COMMENTS & RESPONSES

1415 Mission Street Mixed-Use Development

PLANNING DEPARTMENT CASE NO. 2005.0540E

OCTOBER 29, 2009

Zoning Use and Height and Bulk Districts Figure C&R.1
(Draft EIR Figure 9)

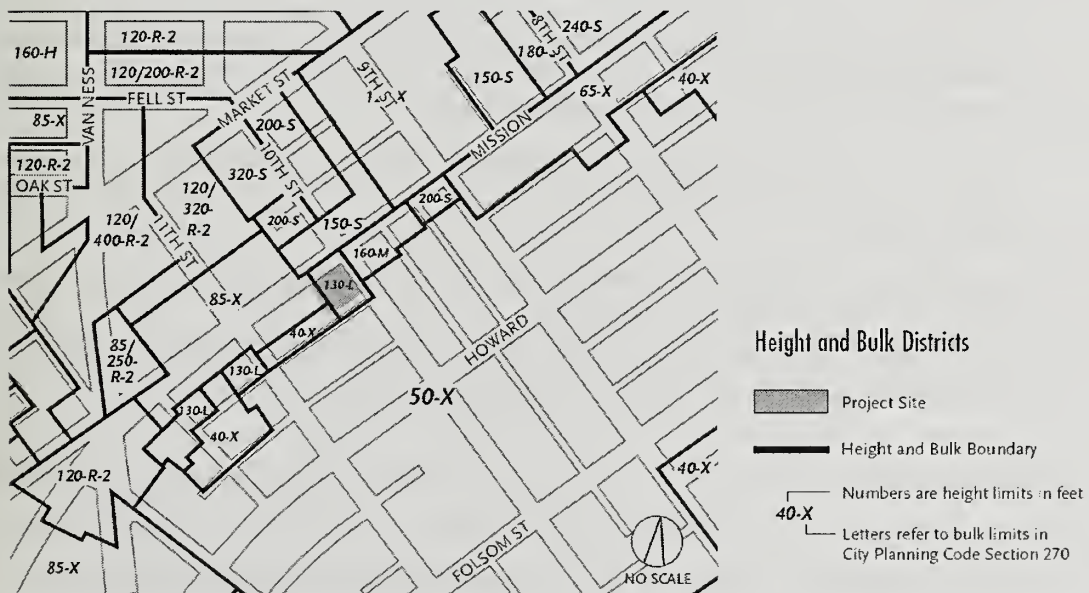
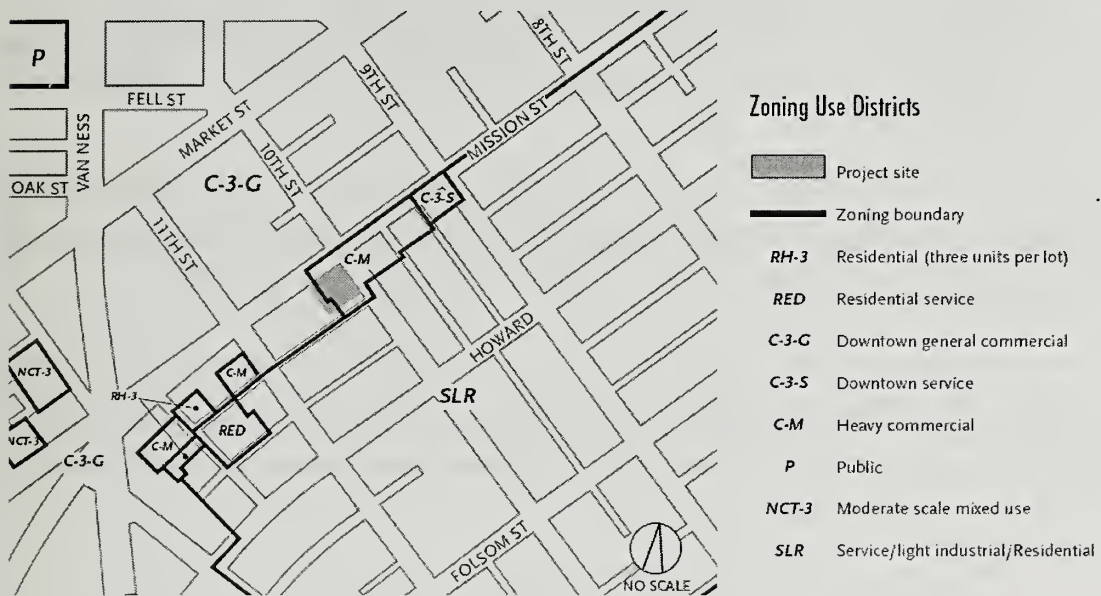
“...Primarily, in terms of building height: Going through the urban design element of the Planning Department, there’s a number of things you will find in that packet that I have distributed that talk about transition between neighborhood and appropriateness of height and bulk for certain neighborhoods.

“Our neighborhood is an RED [Residential Enclave District] with a 40- to 50-X height whereas on the north side of Mission it goes up as high as 320 feet. There’s a lot of questions about that.” (*Eric Dash, Natoma Street Neighborhood Group, public hearing comments*)

"The reference to the West SOMA Plan boundary ending at Minna would be more understandable if there was a map labeling Minna and showing the Plan boundary." (*Sue Hestor, written comments*)

The discussion of land use and height and bulk in the Setting section provides contextual baseline information on existing conditions. Figure 9, Zoning Use and Height and Bulk Districts, Draft EIR page 44 is reproduced here for ease of reading, as Figure C&R.1 on the following page. As shown in the figure, the project site is within a two- to three-block-long, approximately one-block-wide area along the south side of Mission Street that is zoned C-M (Heavy Commercial). The project area includes a complex pattern of varied zoning districts and height and bulk districts along with land uses and building heights and massing. The area lies between the C-3-G (Downtown General Commercial) District to the north, which has height districts ranging from 40 feet to 400 feet, and the SLR (Service, Light Industrial, Residential) District, beginning on the south side of Minna Street, with its maximum 50-foot allowable height. There is a small, one-half-block island of RED one block southwest of the project site, along with small (less than one block) islands of C-M, RH-3 (Residential, House, Three-Family), and C-3-S (Downtown Support) districts.

Figure 9 shows that the *Planning Code* does provide for gradual transitions in the wider area around the project site. With some of the immediately surrounding height and bulk districts, the figure shows sharp contrasts of height juxtapositions, including 130-L and 40-X, 130-L and 85-X, 85-X and 40-X, 130-L and 50-X, 160-M and 50-X, 200-S and 50-X, 85-X and 120-400, 320-S and 200-S. The project site’s 130-foot height limit is both lower and higher than that on some adjacent parcels, and on parcels north and south of Mission Street. The area on the north side of Minna Street, a narrow, minor street (or alleyway), is mapped as a 40-foot height limit within the Market-Octavia Area Plan partly because of the alleyway’s narrowness. The project is in a transitional area from the higher heights to the north and the lower heights to the south.

Figure C&R.1, above, illustrates the existing plans for the area around the project site, including the northern boundary of the Western SoMa Plan.

Area Plan Boundaries Figure C&R.2

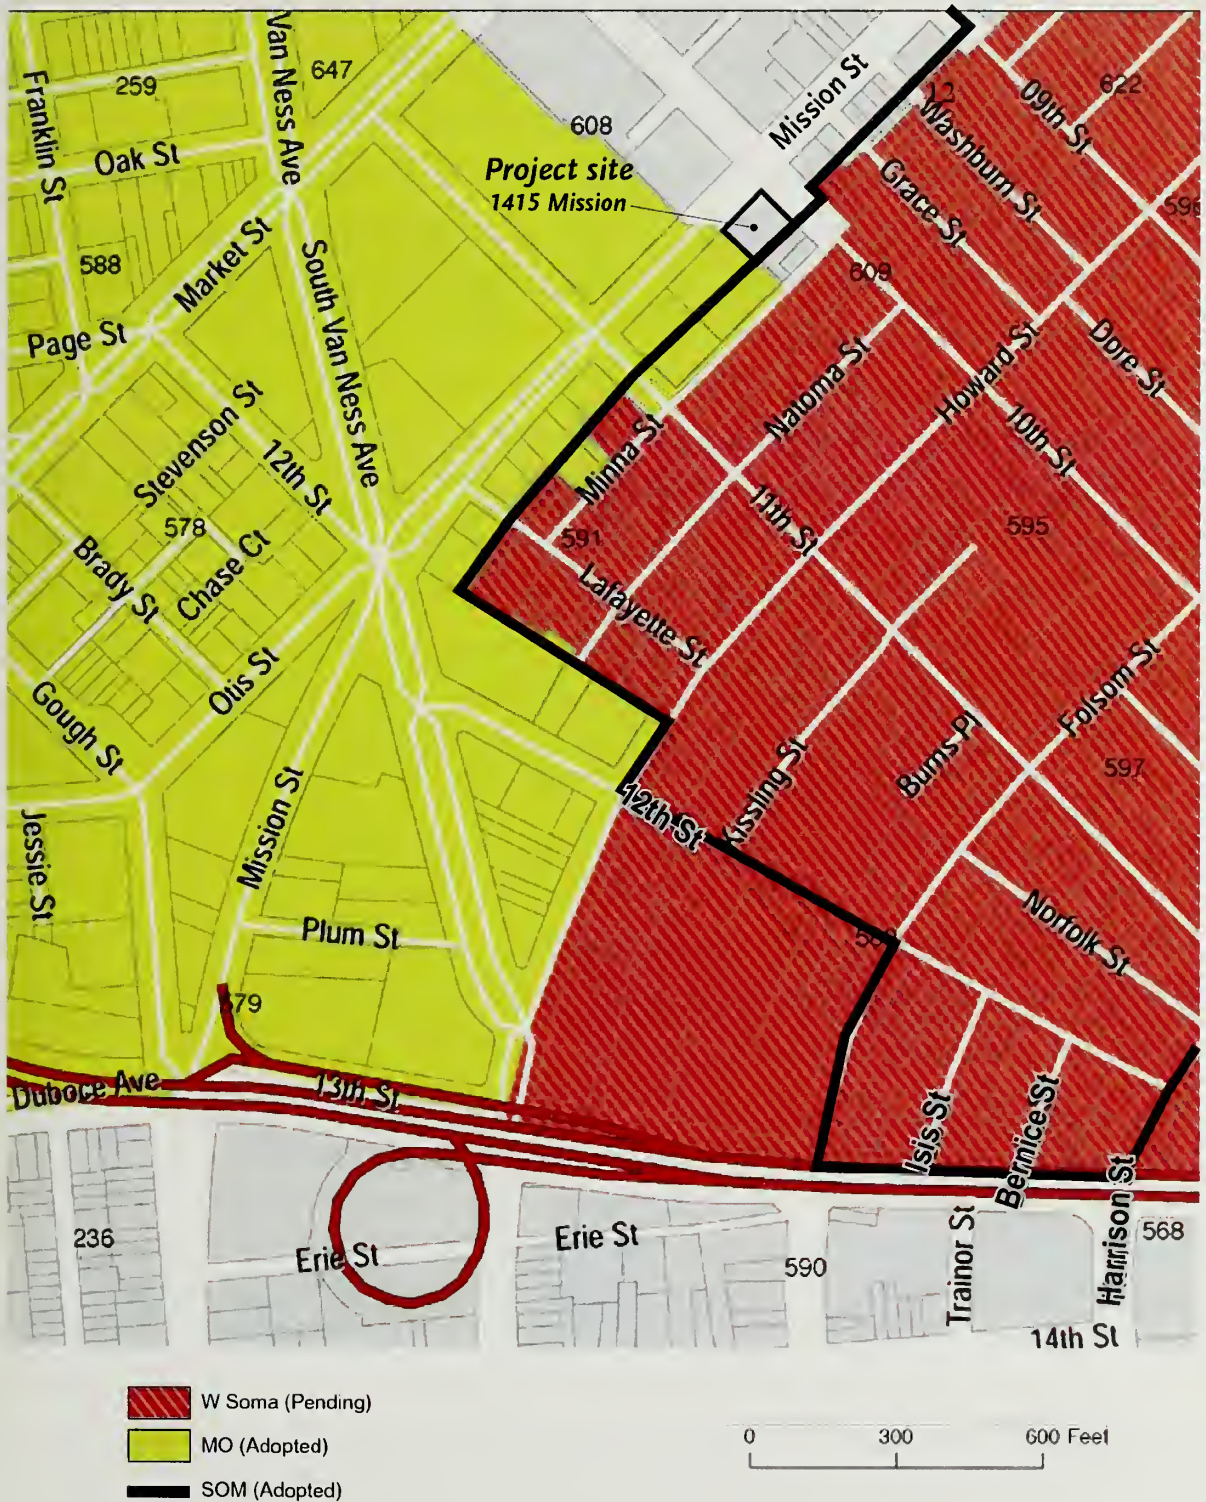
"p. 44 Area Plans—please show on a map the most recent area plans that govern this area, along with information on when they were adopted. This would include: Market-Octavia Plan, Downtown Plan, boundaries of the 'currently undergoing environmental review' West SOMA Plan, the 1990 South of Market Plan which guides the area south of Mission until it is revised. In the case of this site, which has

C-M zoning and a 130-foot height limit, please also provide the date that C-M zoning was imposed, as well as the date of the 130' height.

"I believe that an honest description of this area would show attempts from the 1980s to present to relate the zoning to the existing lower scale of development south of Mission (e.g. this site) as compared to the higher heights north of Mission. The maps don't explain much." (*Sue Hestor, written comments*)

The project site is at the edge of or near a variety of districts addressing multiple planning conditions and purposes. Figure C&R.2, on the next page, illustrates the boundaries of the existing plans around the project site. Neither the Market-Octavia Plan nor the 1990 South of Market (SOM) Area Plan guide development on the project site because the project site is not located within either plan area. Nor is the project site within the proposed Draft Western SoMa Plan area. The project site has been zoned C-M for at least the past 30 years.

Picture 1 - View of CIIS and 122 10th Street and blocked windows and views due to 1415 Mission Street

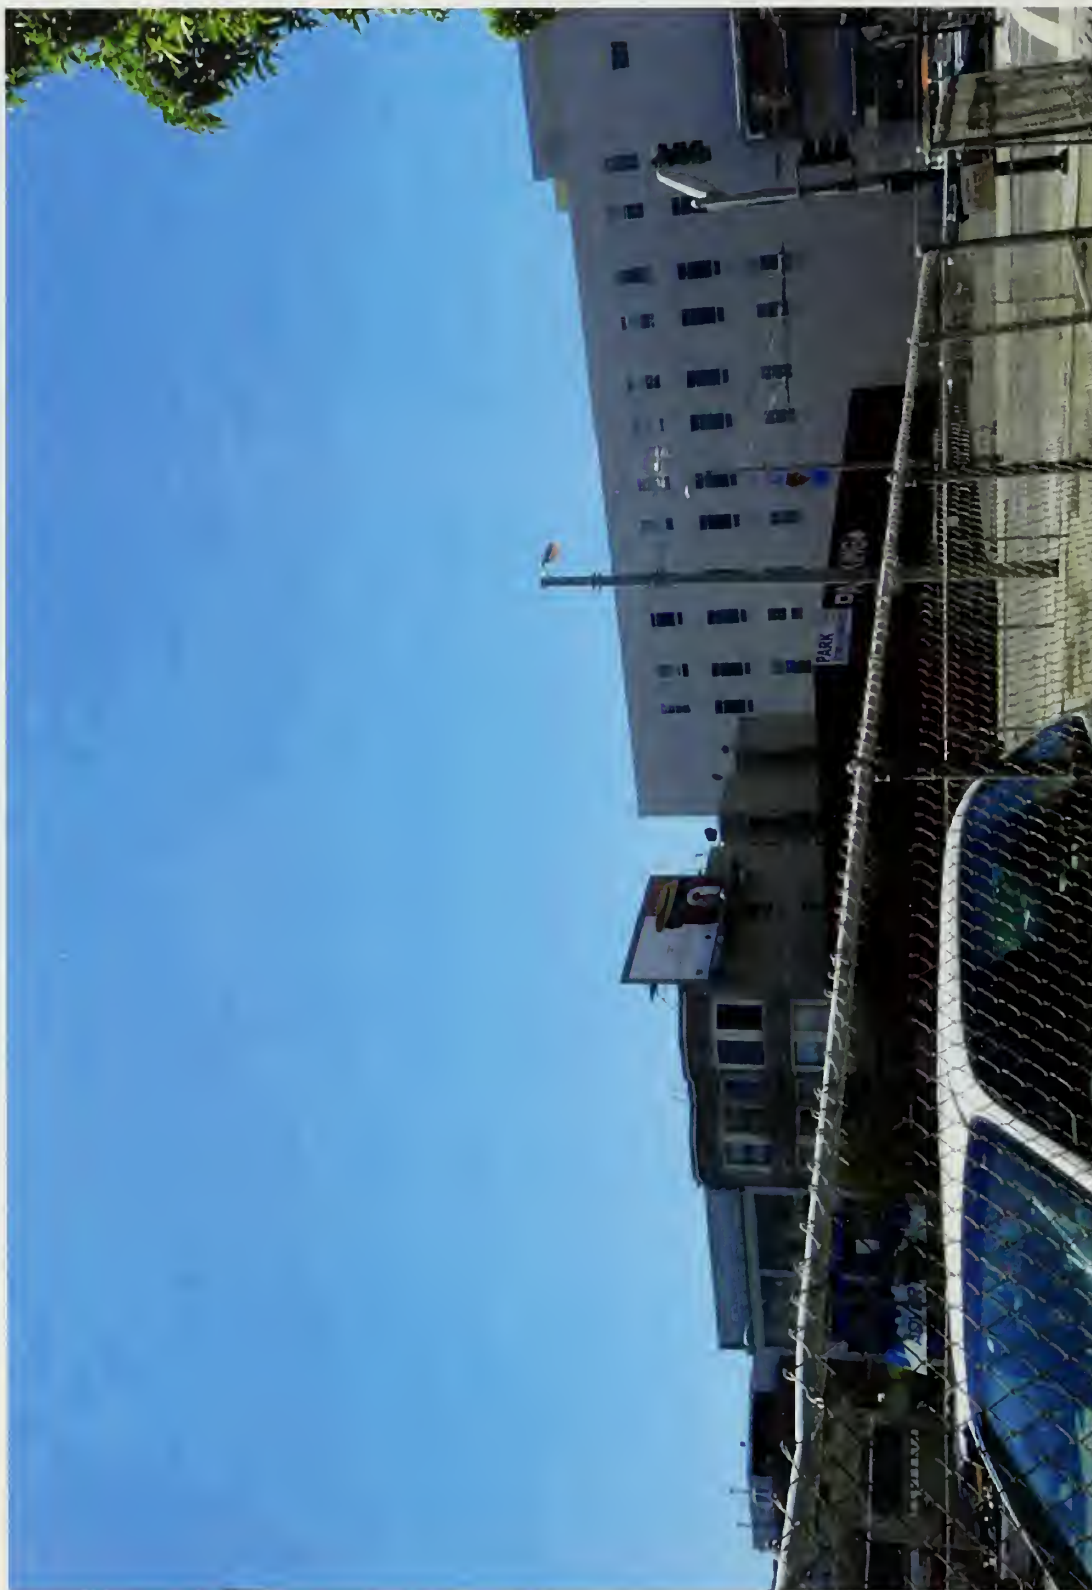
- "• The RED on the north side of Minna is 40 foot zoning and all of Natoma is 50 foot zoning along with the greater part of 10th Street south Mission beginning at the south side of Minna Street. This borders the project immediately to the south.
- "• Market/Octavia on the south side of Mission Street, up to the eastern boundary of CIIS at 1453 Mission, was re-zoned down to 85 feet from 130 feet. This is the border immediately to the west of the proposed project. The CIIS building is 85 feet tall. All of its windows facing east will be blocked. (See picture 1 [following page]).
- "• 122 10th Street is directly adjacent to the south and its north windows would be fully blocked. This building is only 3 stories tall and immediately adjacent to the site with 40 foot zoning (See picture 1 [following page]).

"North Side of Mission Street

- "• All of the building heights above 100 feet are on the north side of Mission Street.
- "• Mercy Housing is 113 feet tall (123 at the top of the equipment).
- "• The southern end of the BofA building between Market and Mission, bordering 11th Street, is only 6 stories tall while the 20 story tower is further north.
- "• The SF Mart and Mart 2 are both the same height as mercy Housing." (*Eric Dash, Natoma Street Neighborhood Group, written comments*)

The parcel to the south of the project site is within a 130-L Height and Bulk District, not 40-X. Only a corner of the property touches on the 40-X Height and Bulk District. See the discussion in Response 4.3, on page C&R.37 below, for more information. The comment incorrectly references RED zoning on the north side of Minna Street; as illustrated on Draft EIR Figure 9, the only RED zoning in the project vicinity is south of Minna and a block and a half west of the project site. The assertion that a 40-foot height limit applies along the north side of Minna and a 50-foot height limit applies to most of the area to the south is correct. However, the adjacent building to the south of the project site, at 122 Tenth Street, is within the same 130-L Height and Bulk District as the project. Its north-facing windows do not comply with the San Francisco *Building Code* (“unprotected” property-line windows). As acknowledged in the comment, the project site is bordered on the east by a 160-foot height district, and by 150-foot, 85-foot, and 130-foot height limits on the north, west, and south, respectively. Height limits of 200 feet, 250 feet, 320 feet, and 400 feet are located between Mission and Market streets in proximity to the project site.

Picture 2 - Views from 940 Natoma Street looking north
There used to be complete views of Grace Cathedral prior to the Argentina

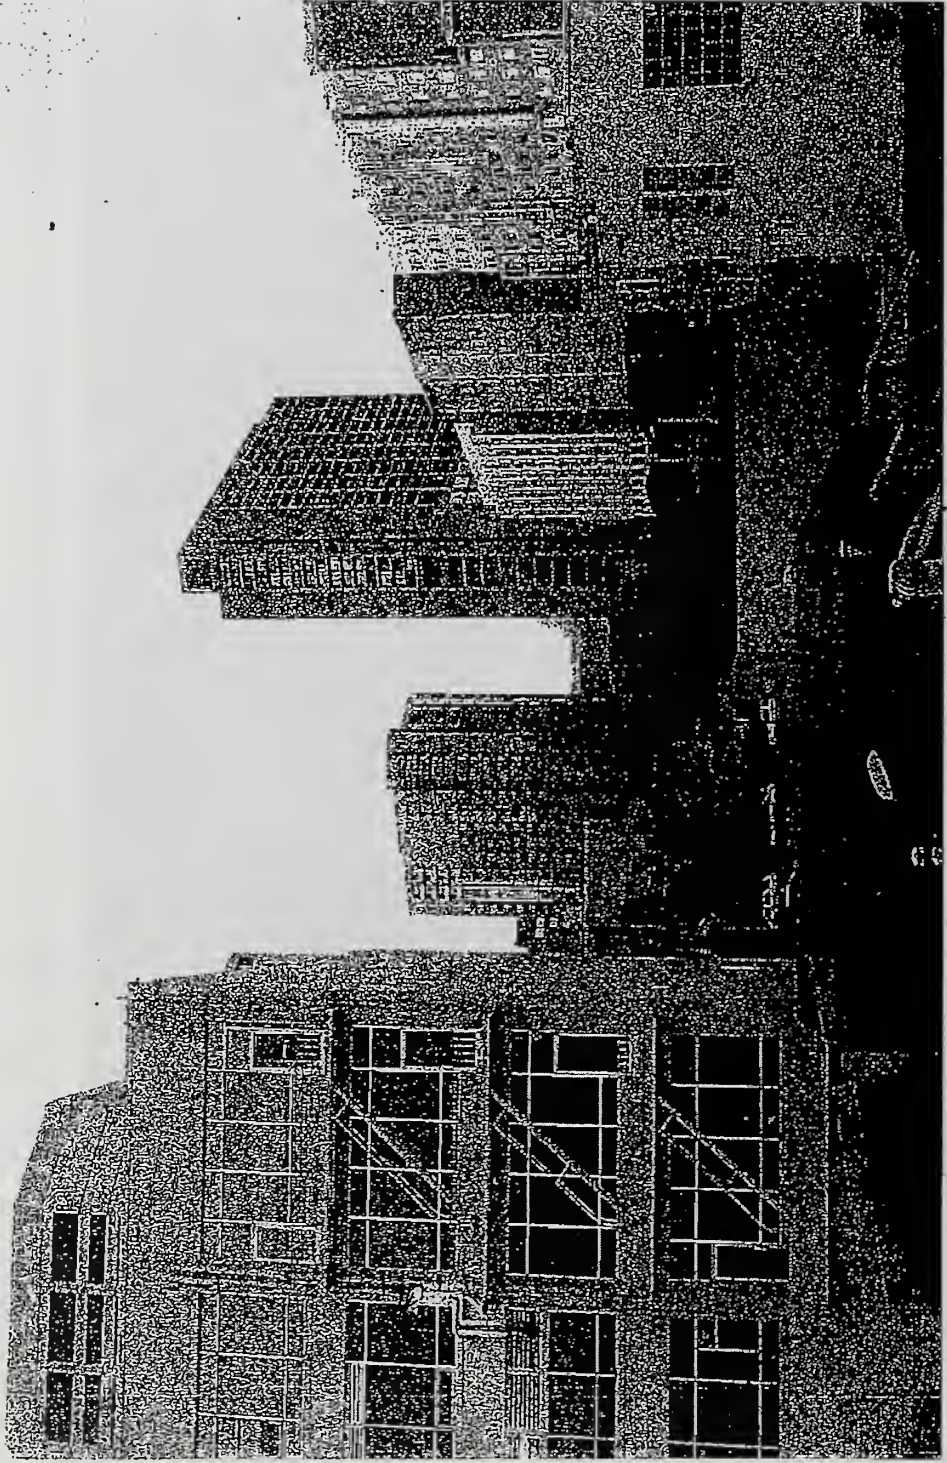
Based on actual walking experiences on 10th Street we feel that until some sort of testing for accuracy has been done on Wind Studies, the neighbors in proximity to the proposed project at 1415 Mission do not feel that the “the proposed project would not contribute to a significant adverse cumulative wind hazard impact.” (p.121). There is too much at risk given the existence of the wind Hazard location at the SW corner of 10th and Market Streets.
